PARIS#13

PROJECT: PARIS #13		
DESIGN TITLE: FIRST DRAFT CHECKED FOR LAYOUT		
AUTHOR: CH'TI LAMPES	DRAWING NUMBER Drawing_nr	REV: 1C
DATE: 2017-03-05	SIZE: A4	SHEET: 1 of 1

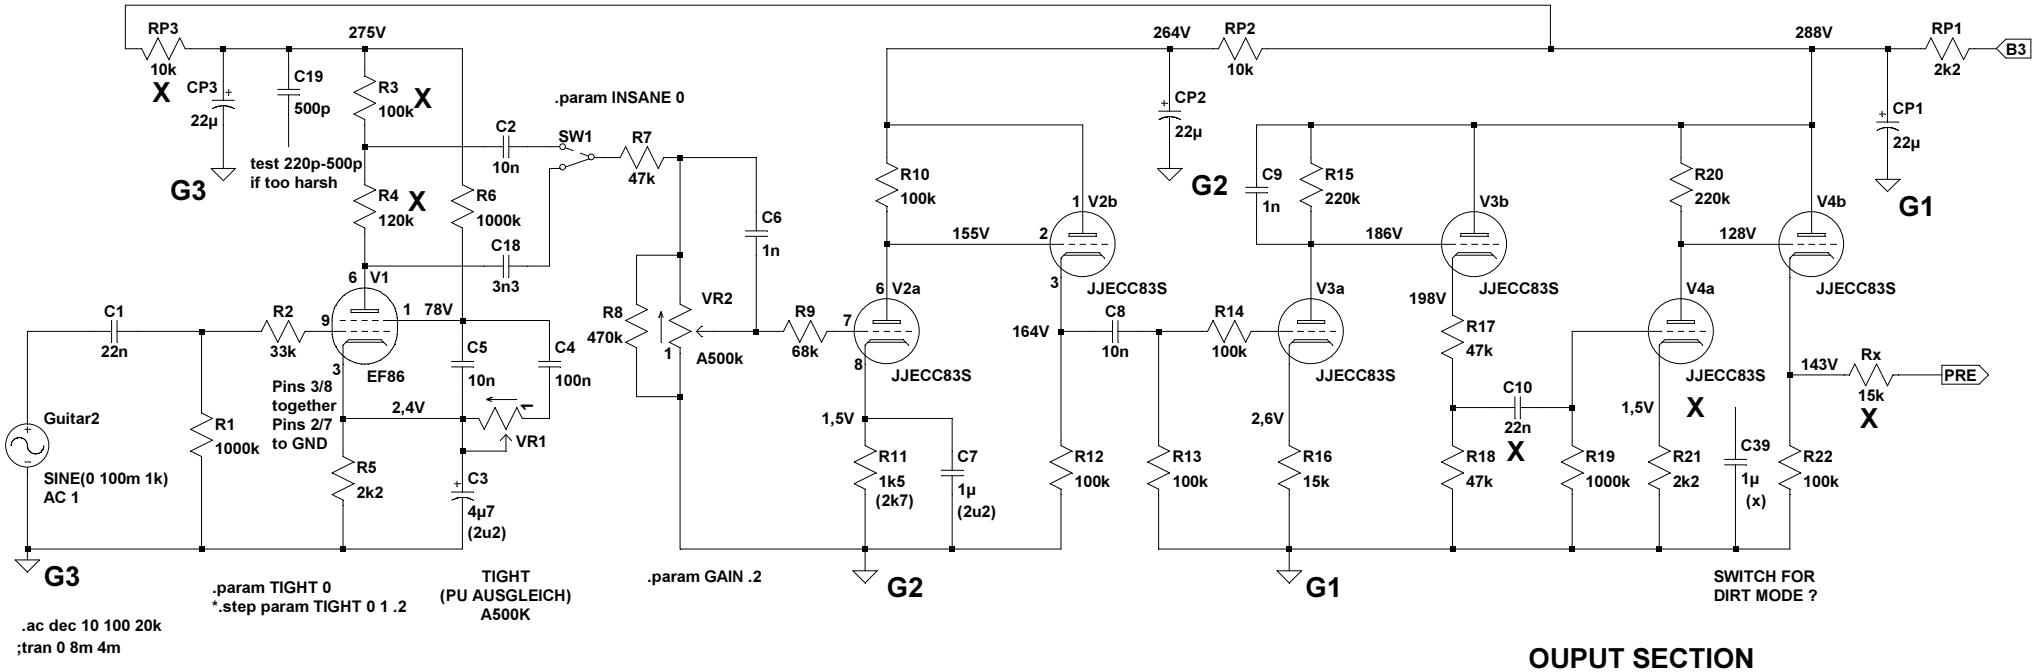
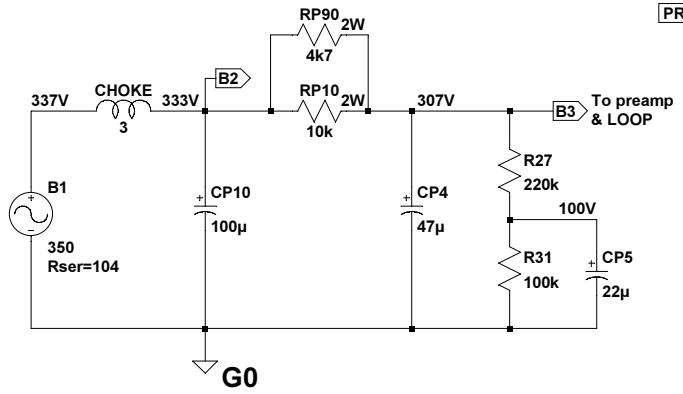
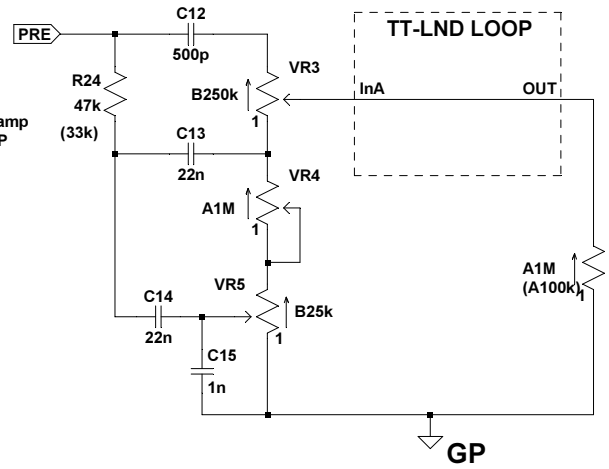
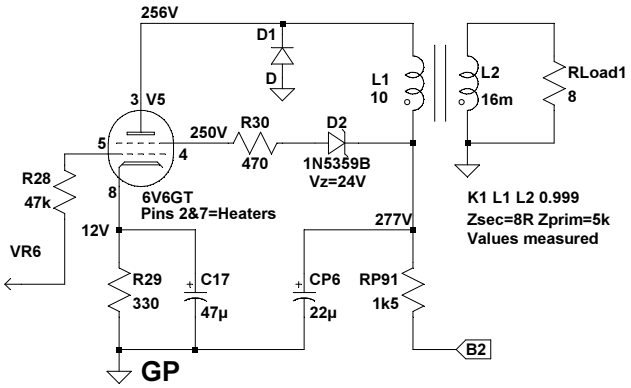
- Loop added
- PSU reviewed for more voltage to preamp
- VoCom removed and replaced by resistor
- Elevation reduced
